Access Compliance Report

Public Rights-of-Way

(Curb Ramps)

Intersection ID: 20140	Main Street: DEERMONT_CT	Cross Street: PINEBURR_RD	Location:	N
ADA ID: 9FC67BC35B6F	Ramp Type: BlendTrans2	Initial Pass/Fail: Fail	Overall Compliance: No	Severity Score: 25
Codes/Mitigation Info/Possible Solution		Field Measurements/Component Compliance

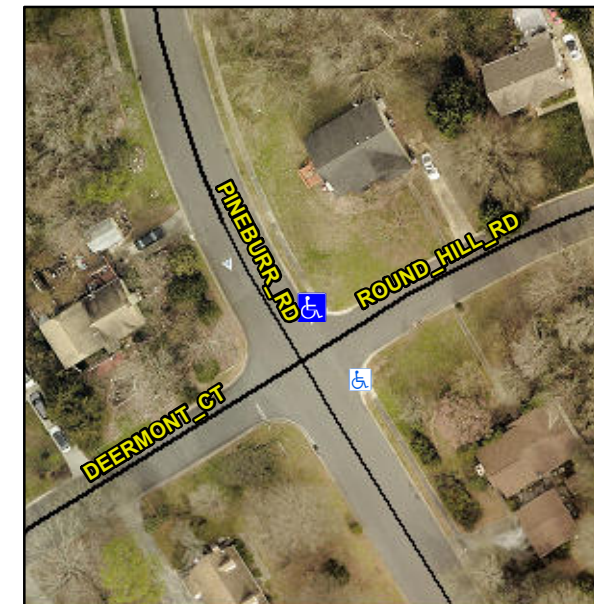
Not Found, R304.5.3

Compliance	Description	Data	Compliance	Description	Data
N/A	Ramp Length (in)	65.0	Yes	BlendTrans Slope (%)	2.0
Yes	Ramp Width (in)	48.0	No	BlendTrans XSlope (%)	8.9
N/A	Flare Type LT	N/A	N/A	Flare Type RT	N/A
N/A	Flare Slope LT (%)	N/A	N/A	Flare Slope RT (%)	N/A
N/A	Flare Traversable LT?	N/A	N/A	Flare Traversable RT?	N/A
N/A	Landing Length (in)	N/A	N/A	DWS Provided?	N/A
N/A	Landing Width (in)	N/A	N/A	DWS Contrast?	N/A
N/A	Landing Slope (%)	N/A	N/A	DWS Length (in)	N/A
N/A	Landing X Slope (%)	N/A	N/A	DWS Full Width?	N/A
N/A	Landing Curb? (Y/N)	N/A	N/A	DWS Offset (in)	N/A
N/A	Shared Landing?	N/A			
N/A	Gutter Ponding?	N/A	N/A	Gutter Slope (%)	N/A
N/A	Gutter Lip Ht (in)	N/A	N/A	Gutter X Slope (%)	N/A
N/A	Painted X Walk1?	No	N/A	Painted X Walk2?	No
	X Walk 1 Direction	To SW		X Walk 2 Direction	To SE
	X Walk 1 Width (in)	N/A		X Walk 2 Width (in)	N/A
	X Walk 1 Slope (%)	5.1		X Walk 2 Slope (%)	12.7
	X Walk 1 X Slope (%)	10.5		X Walk 2 X Slope (%)	0.5

N/A	Ramp inside XWalk1?	N/A	N/A	Ramp inside XWalk2?	N/A
	Road Slope (%)	9.0		Clear Space?	N/A
	Road X Slope (%)	6.0	N/A	Clear Space to XWalk (in)	N/A
N/A	Any Obstructions?	N/A	N/A	Storm Grate/Utility Hazard?	N/A
	Obstruction Type			Storm Grate/Utility Type	
		N/A			N/A
			Yes	Surface Condition? (G/P)	Good
			No	Curb Slope (%)	11.1

Remove & Replace Curb Ramp With Two New Directional Ramps or Equivalent.
